Service Bulletin No. 414

<i>MODEL</i>	D Series	<i>TYPE</i>	Field Change Program	<i>SECTION/GROUP</i>	3-Body	<i>DATE</i>	
<i>SUBJECT</i>	DRIVESHAFT CONTAINMENT						
<i>CONDITIONS</i>

Ref. NHTSA Recall No.:14V-335

Figure 6.

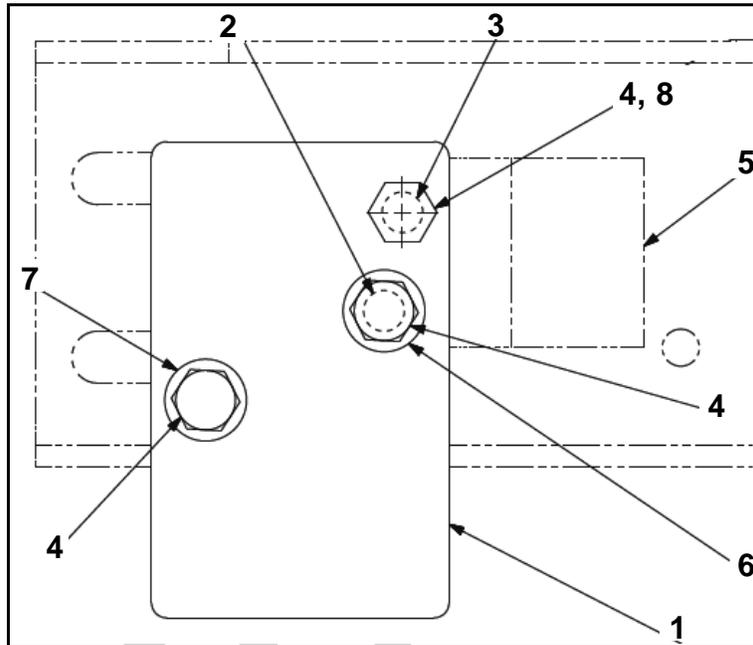
10. Align the indicated hole (Item 3 in Figure 6) in plate, p/n 03-33-2834, with the existing hole in the welded bracket. Secure with hardware.
11. Using a 0.343 drill bit and the plate as a template, drill a hole through the welded bracket (Item 2 in Figure 6).
12. Re-install the protection valve using the hardware provided in the Parts list. Re-orient fitting and airlines and secure with a tyrap, p/n 19-11-258.

Item	Description
1	Plate
2	Drill a 0.343 inch hole at this location
3	Hole for alignment
4	Lock nut, p/n 19-03-0498
5	Welded bracket reference
6	Capscrew, p/n 19-1-736
7	Capscrew, p/n 19-1-260
8	Capscrew, p/n 19-1-17

Figure 7. Plate installation.

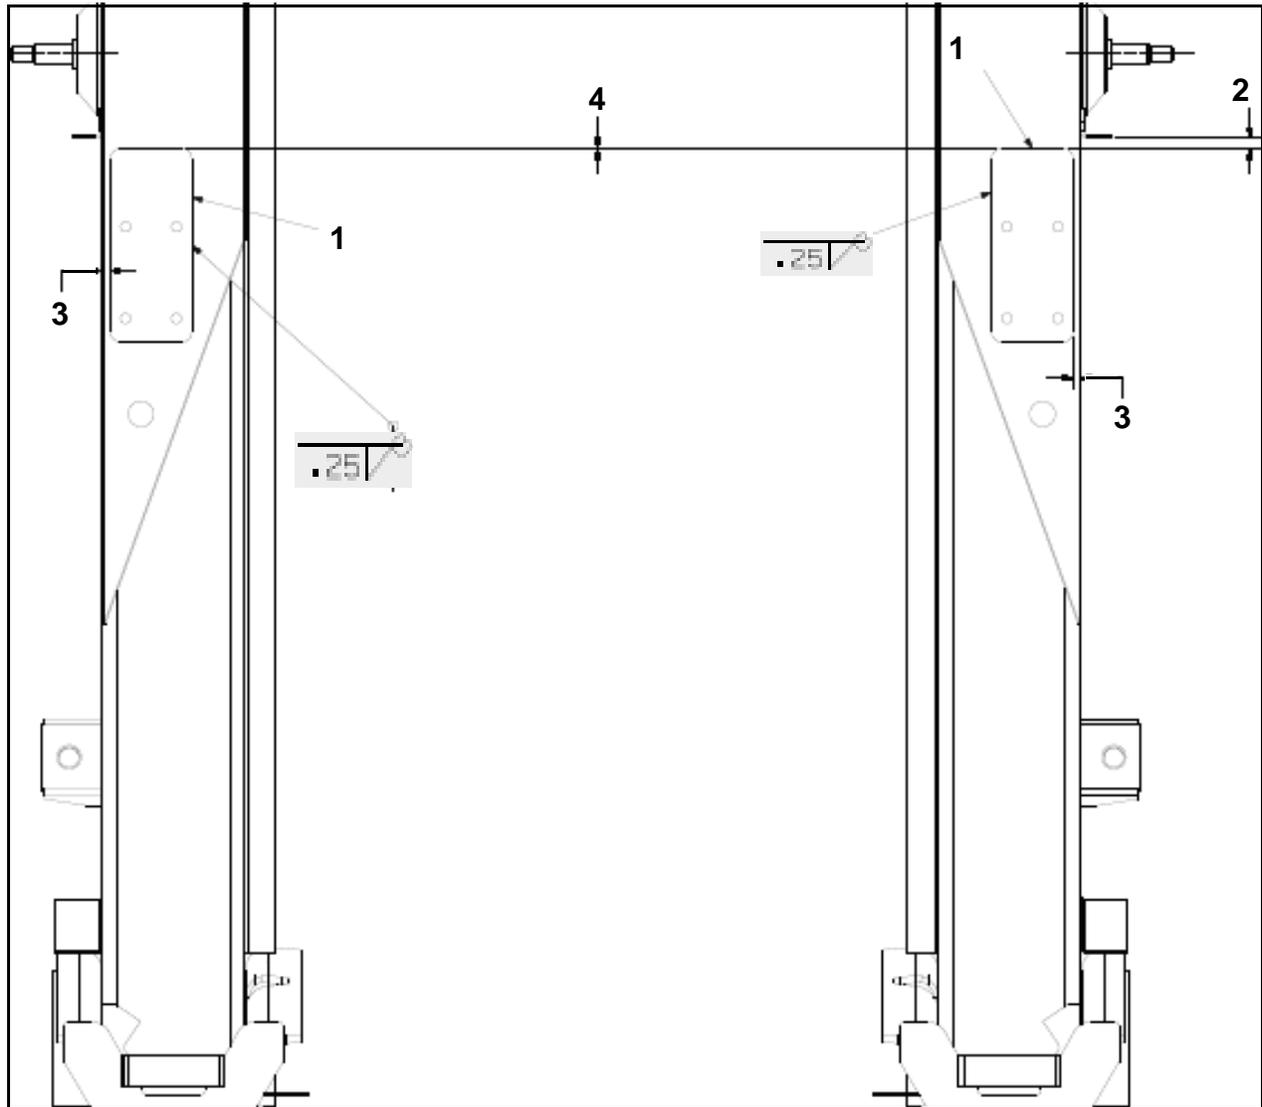
13. Position the tapped plate, p/n 03-56-1642, on the bogie structure as outlined in Figures 7 and 8. Mark a chalk outline around the entire plate. Remove plate. Repeat step to opposite side of the coach.
14. Using a wire brush, thoroughly clean the surface area of dirt and grease from the location(s) where the tapped plate(s) will be welded.

15. Tack weld the tapped plate on both sides of the coach. Orient the driveshaft hoop assembly, p/n 03-33-2711, with the holes in the tapped plates to ensure correct installation. Place the driveshaft hoop assembly aside to be re-installed at a later step in this procedure.
16. Weld the plate according to the welding symbol in Figure 7, using the following method,
 1. SHIELDED METAL ARC WELDING (SMAW)
 - a. 1/8 rod - 7018, 100A-115A
 - or,
 2. GAS METAL ARC WELDING (GMAW)
 - a. 0.045 diameter - 70S3, 25V-26V or 300-320 1PM
17. Repeat Step 16 to opposite side of coach.

Item	Description
1	Plate, tapped
2	0.50 inch
3	0.38 inch
4	0.00 inch

Figure 8. Hoop assembly installation.

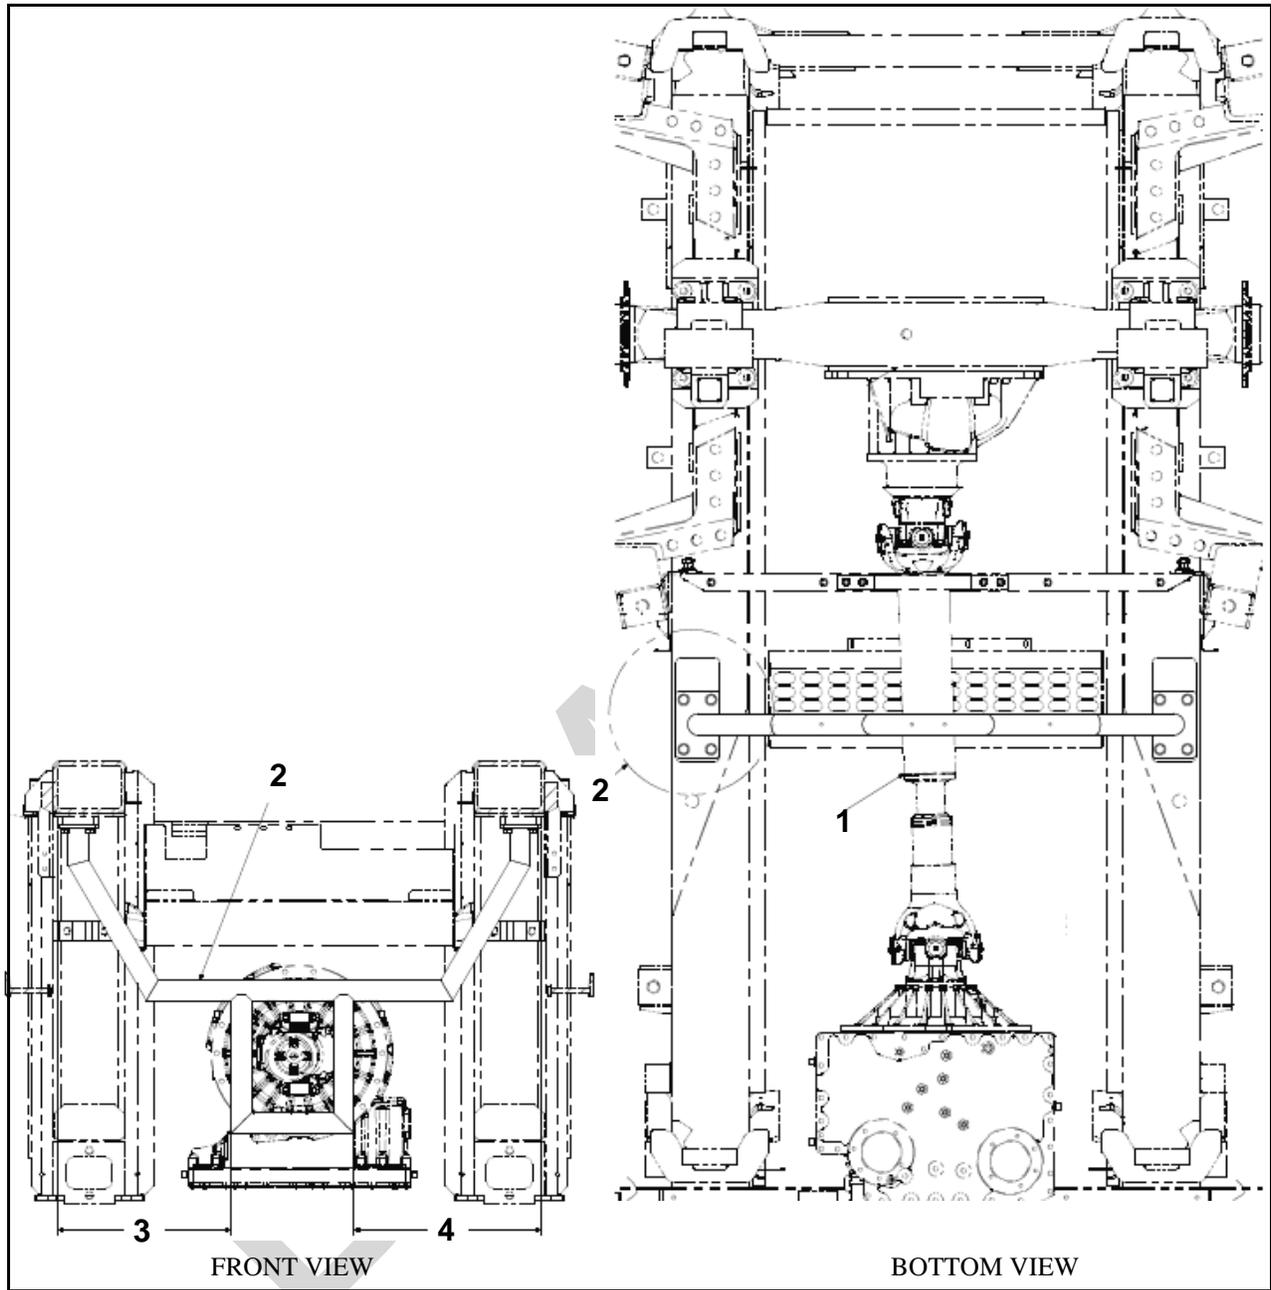
18. Orient the driveshaft hoop assembly, p/n 03-33-2711, as shown per the views and dimensions provided in Figure 8.
19. Apply Never Seez to the threads of the capscrews, p/n 19-01-1535. Using the capscrews, secure the hoop assembly to the tapped plates welded in Step 16. Torque capscrews to 75-80 ft-lbs.

Item	Description
1	Driveshaft
2	Hoop Assembly, Driveshaft
3	16.93 inch
4	18.30 inch

Figure 9. Driveshaft hoop assembly installation.

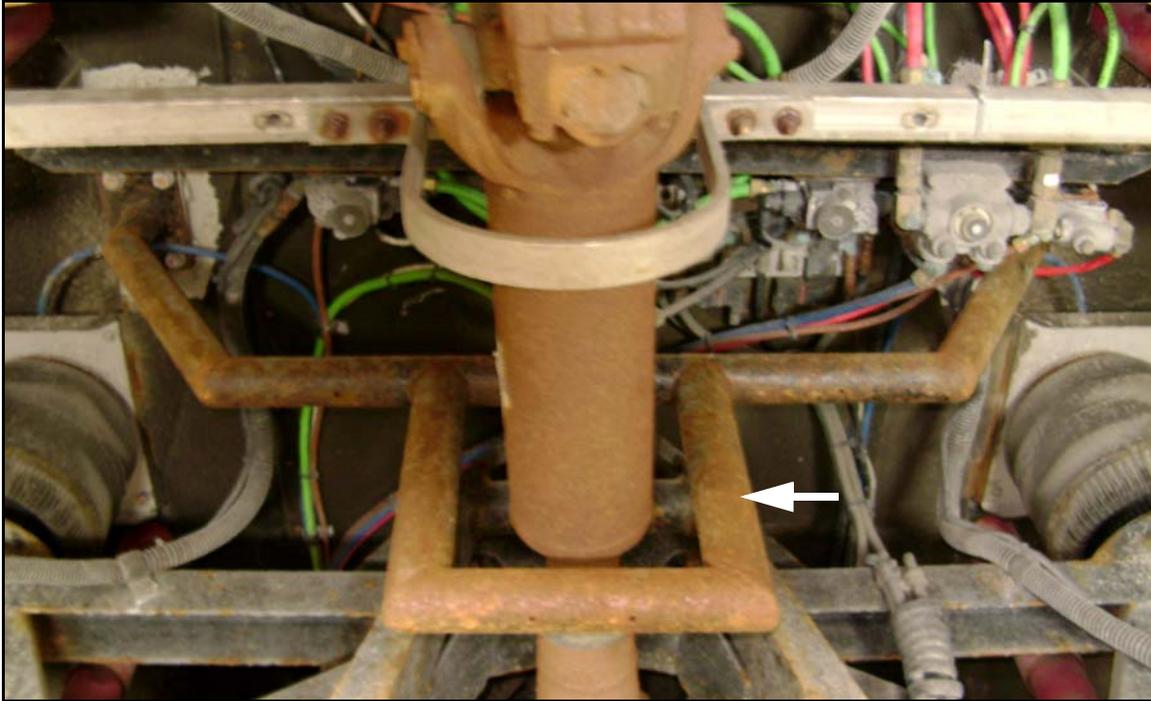
20. Orient the driveshaft per the labeling earlier in this procedure. Insert the driveshaft through the lower opening of the hoop assembly as shown in Figure 9. Using two (2) strap / bolt kits, p/n 14-01-1028, attach the driveshaft to the yoke flange on the transmission (refer to Figure 10). Torque to 115-125 ft-lbs.
21. Using two (2) strap / bolt kits, p/n 14-01-1028, attach the opposite end of the driveshaft to the yoke flange on the drive axle (refer to Figure 10). Torque to 115-125 ft-lbs.
